ROUNDEL HOMES INC. (PH-2)

PROJ. No. 23-01

LOT No. 51

PRAIRIE ROSE DRIVE

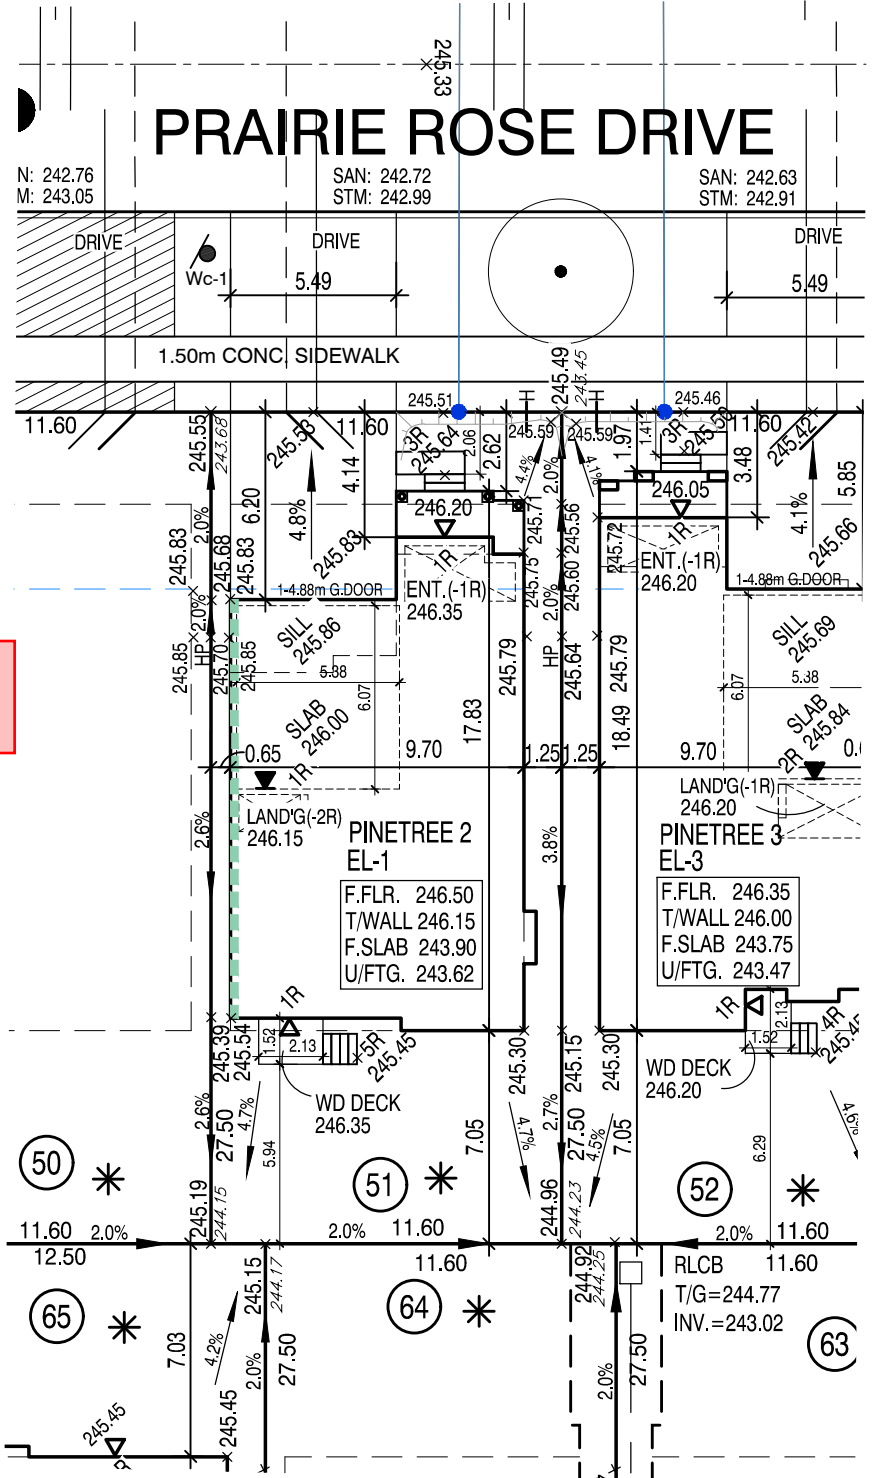
No unprotected openings permitted within 1.2 metres of the lot line as per 9.10.14 of the Ontario Building Code.

45 MINUTE RATED WALL  
WITH SIDE YARD < 1.2m
